ALERT SERVICE BULLETIN

205-17-115  
3 March 2017

**MODEL AFFECTED:** 205A/205A-1

**SUBJECT:** MAGNETIC BRAKE ASSEMBLY 204-001-376-003,  
INSPECTION AND REPAIR OF.

Figure 1. Magnetic brake assembly.

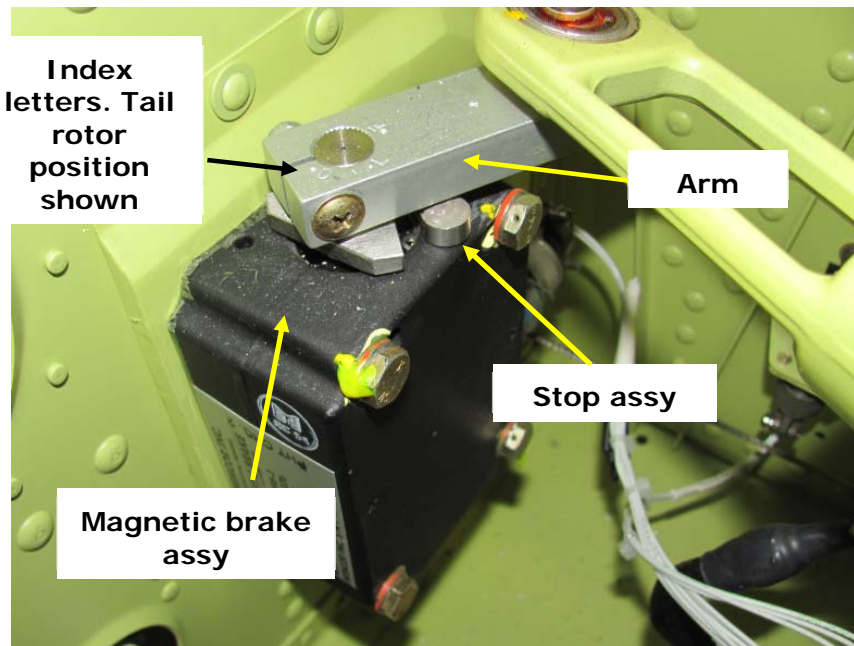
1. Prepare the helicopter for maintenance.
2. Gain access to the cyclic and tail rotor magnetic brake assembly (BHT-205A1-MM).
3. Perform a detailed visual inspection of the stop assemblies (Figures 1 and 2). Figures 3 and 4 show a stop assembly found disbonded.

Figure 3. Stop assembly with disbonded shaft.

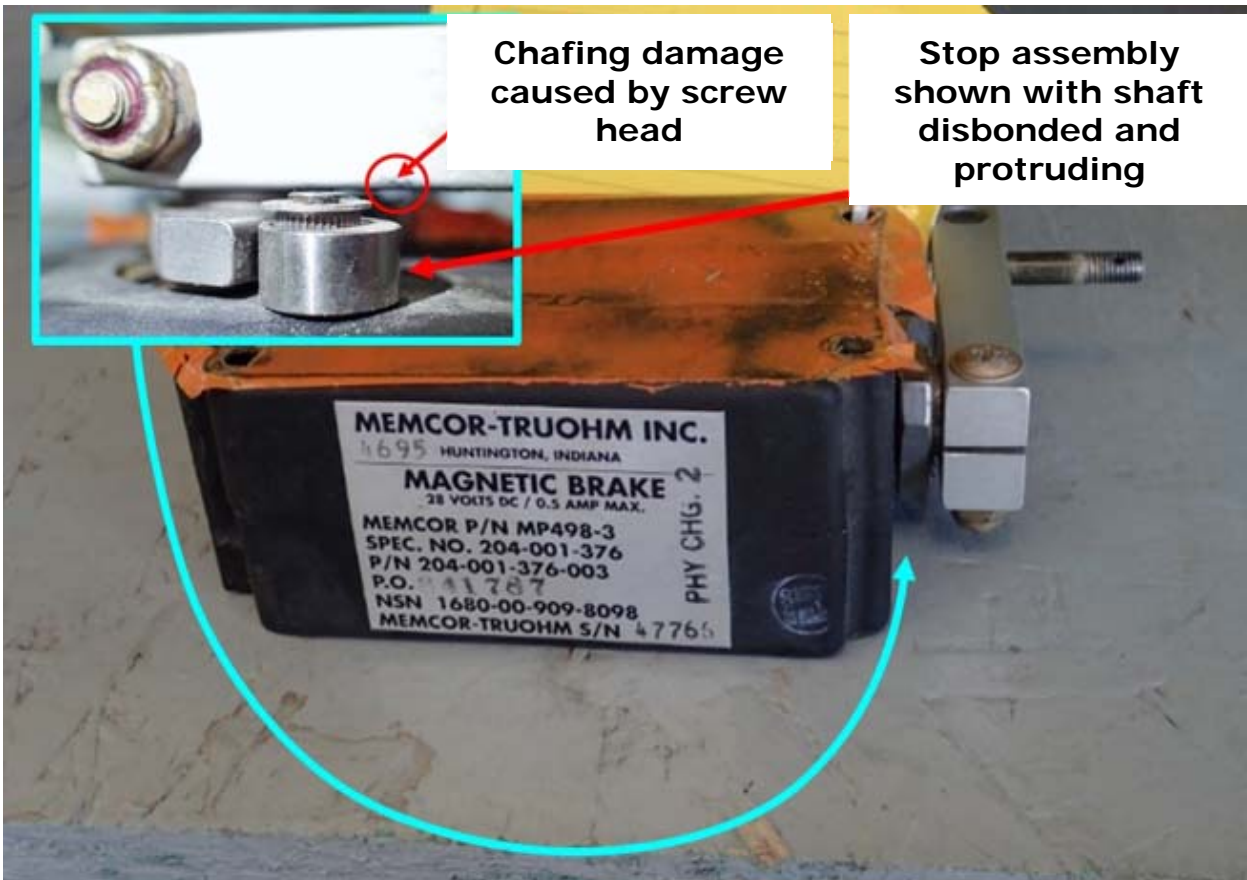
4. By hand, pull on the stop assembly to verify if the stop shaft is disbonded from the housing assembly.
5. If the shaft shows evidence of disbonding, inspect the lower side of the arm for possible chafing damage and accomplish Part II. The maximum allowable mechanical damage is 0.030 inch. (0.762 mm).
